NUREG-1861

Peer Review of GSI-191 Chemical Effects Research Program

Peer Review of GSI-191 Chemical Effects Research Program

Manuscript Completed: July 2006
Date Published: December 2006

Elements in the solution as a function of time (a) and Ca and Na vs. Si (b)

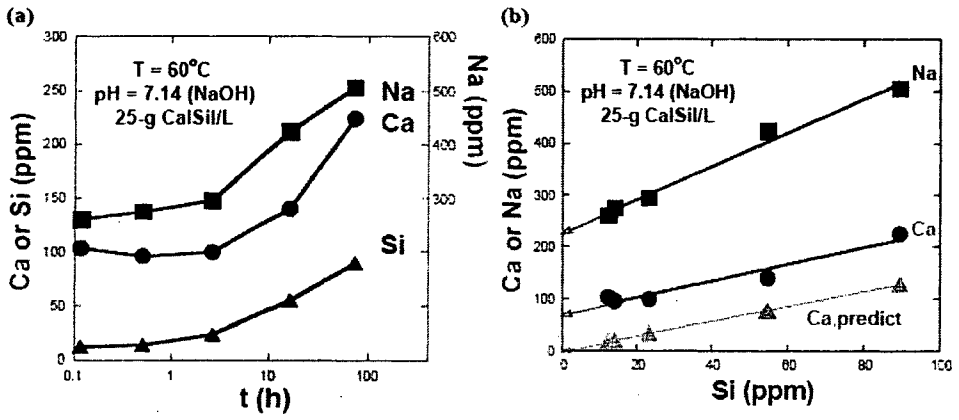
- The Cal-Sil dissolution information (below) shows increasing dissolution with time. Does this increase continue with time? What do the solids look like?
